MFN 06-218, Supplement 1

Subject: **Response to Portion of NRC Request for Additional  
Information Letter No. 35 Related to ESBWR Design  
Certification Application – Radioactive Waste Management  
Systems – RAI Number 11.4-6 S01**

**RAI Number 11.4-6 S01 Items a through c**

**DCD Markups**

**Table 11.4-2**  
**Annual Shipped Waste Volumes\***

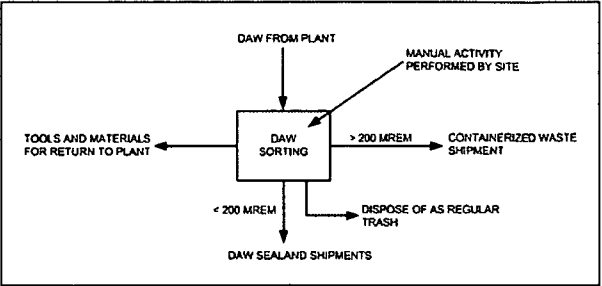
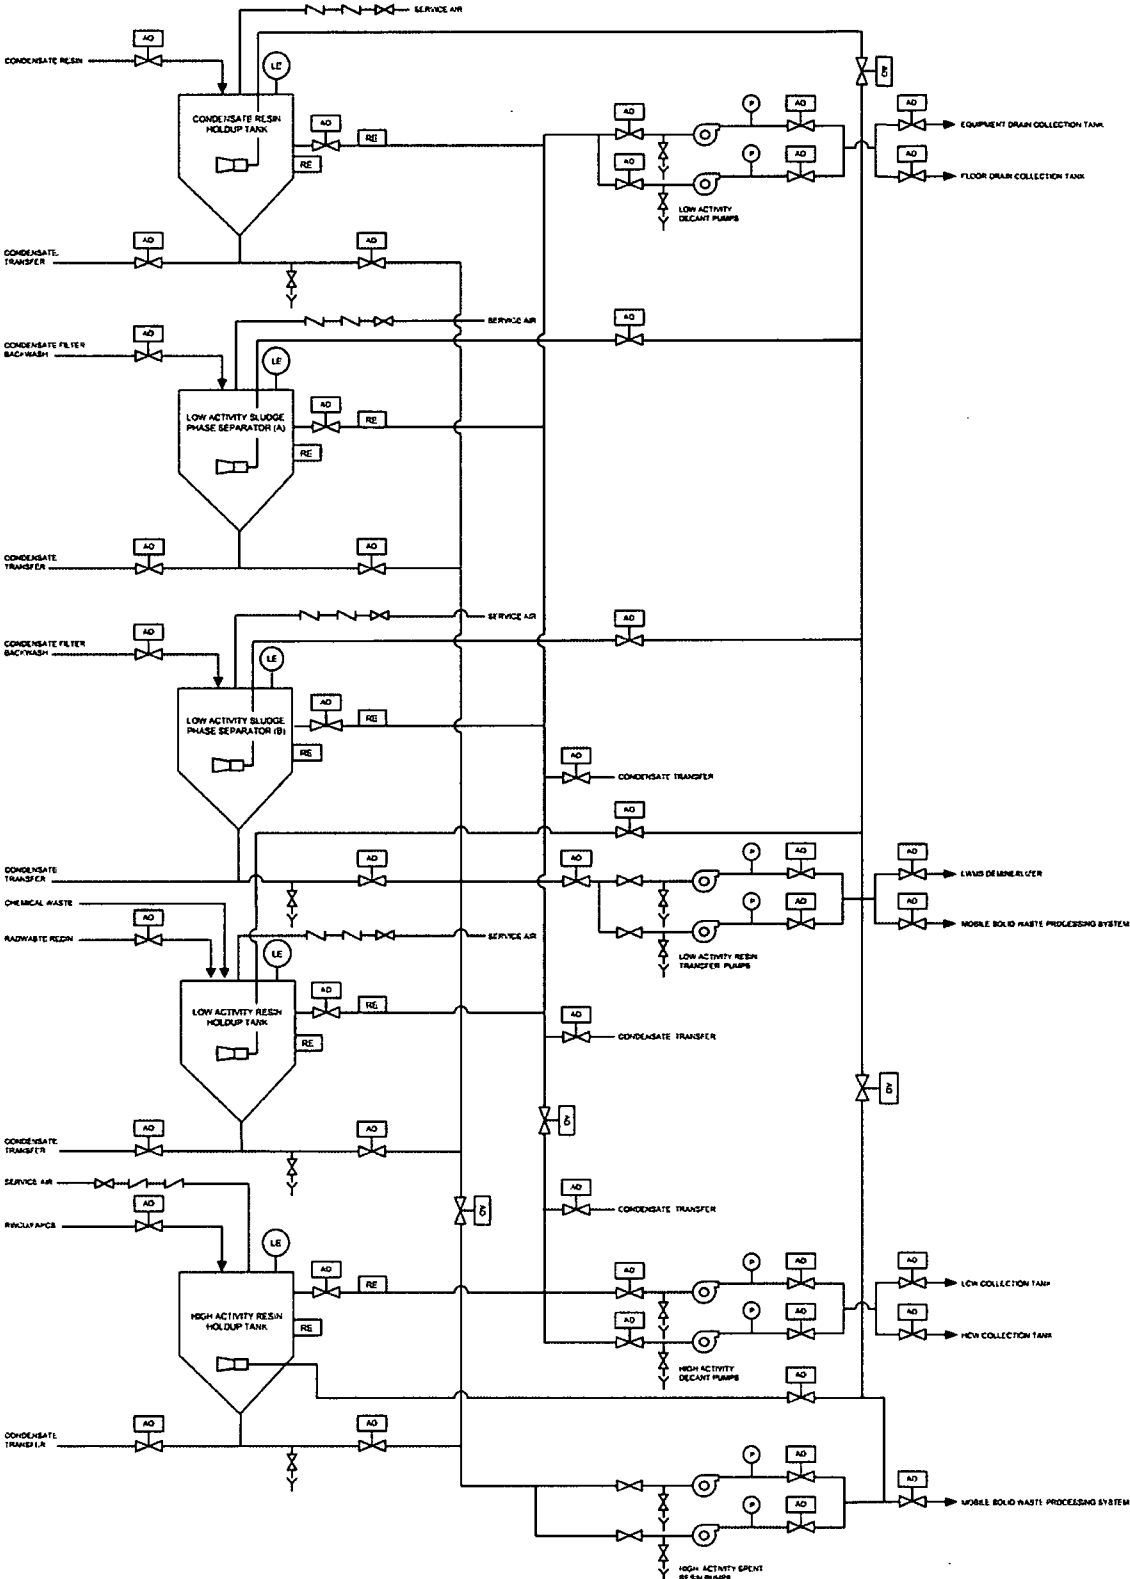
*RAI 11.4-6b - A review of the estimated radwaste inventories listed in DCD Rev. 3, Table 11.4-2 indicates that the amount listed for the Wet Solid Waste Total is inconsistent with each of the listed waste streams comprising this total. Accordingly, update the value of the total waste estimate.*

*RAI 11.4-6c - A review of DCD Rev. 3, Table 11.4-2 indicates that the last footnote refers to the use of evaporation as a mean of achieving waste volume reduction for concentrated wet wastes. However, the use of evaporators is not discussed in DCD Rev. 3, Section 11.4.2. Accordingly, revise the footnote to eliminate evaporation as a waste reduction method or add the use of this type of waste processing technology to DCD Section 11.4.2 and update the associated DCD tables and Figure 11.4-1.*

The HIC return pump (dewatering pump) will be added to Figure 11.4-3. Sorting is a manual activity performed by station personnel and will be shown on Figure 11.4-2. The wet solid waste totals have been updated on Table 11.2-4. The last footnote on Table 11.4-2 has been changed from evaporation to drying, which is discussed Subsection 11.4.2.2 for the description of mobile waste solid waste processing.

- \* ~~Should a COL holder compact~~ If waste is compacted using a third party service, the estimated annual shipped waste volume provided in Table 11.4-2 ~~reduction may be reduced~~ will be considered depending on the type and level of waste and the waste compacting equipment and resulting compaction performance.
- \* Note the goal value is a long term average of resins and sludges in the dewatered condition and all other wastes packaged for shipment. The values for resins and sludges in the above table are volumes packaged for shipment.
- ◇ The volume reduction is based on LWMS Concentrated Waste moisture removal. An estimate of 50% volume reduction is thought to be conservative based on current moisture removal technologies, such as ~~evaporation as~~ drying and membrane-based operations.

Figure 11.4-2. SWMS Spent Resin Sludge Transfer System  
\*Conceptual Design

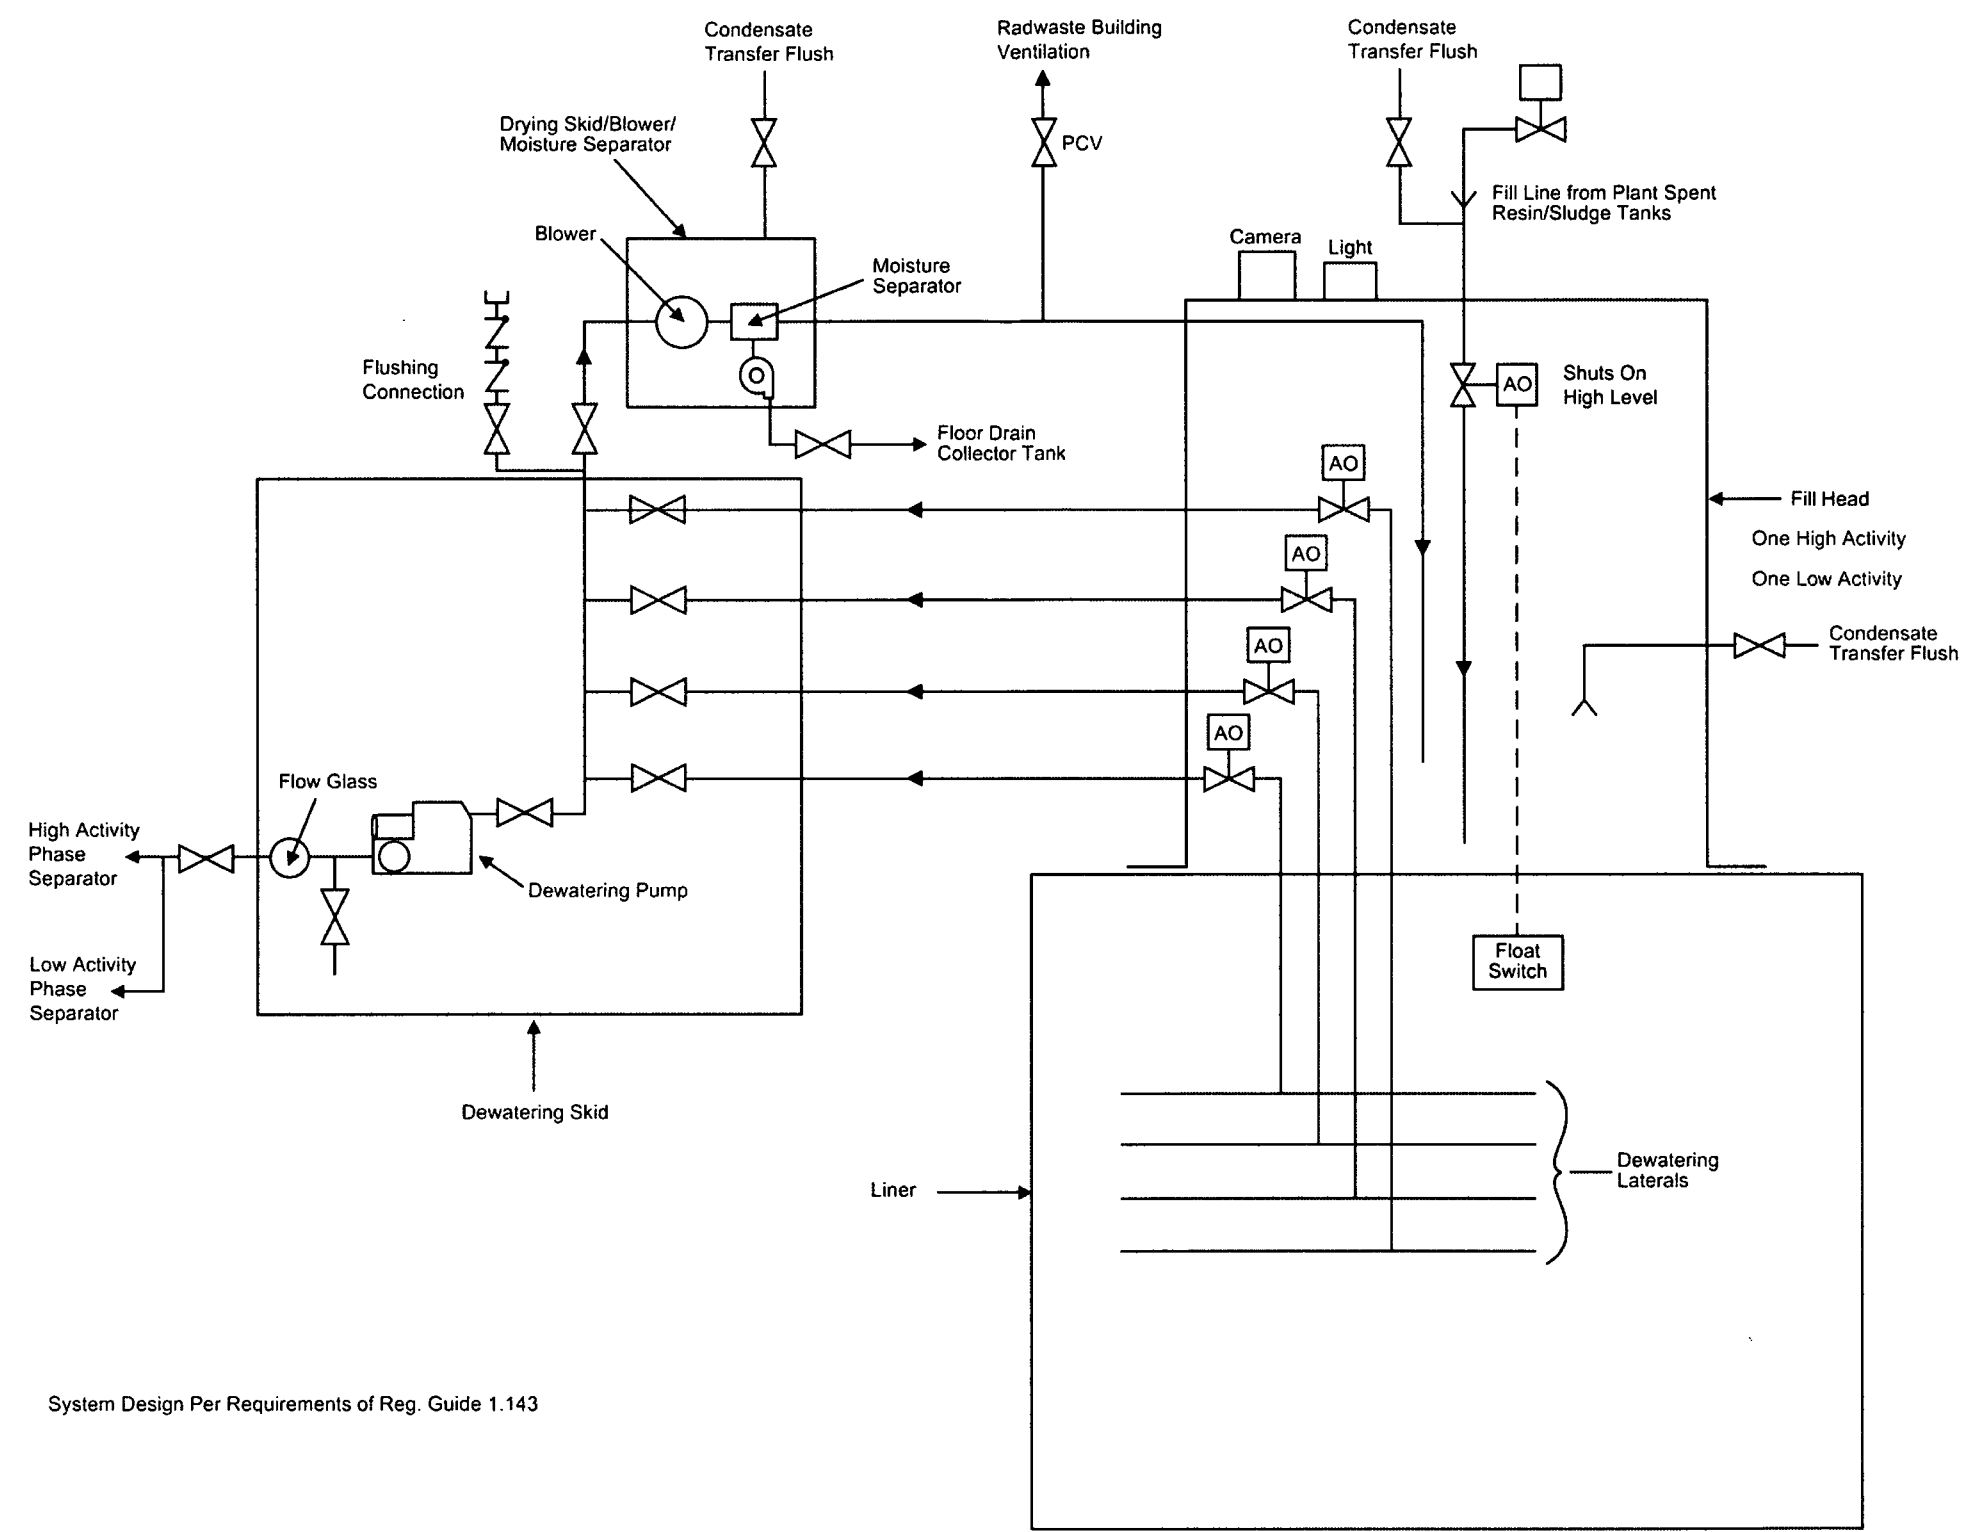
*RAI 11.4-6a - A review of the system components listed in DCD Rev. 3, Table 11.4-1 and Figure 11.4-1 indicates that the HIC Return Pumps and Sorting Table are not shown in Figure 11.4-1. Accordingly, update the table and figure to indicate where in the SWMS these components are located.*
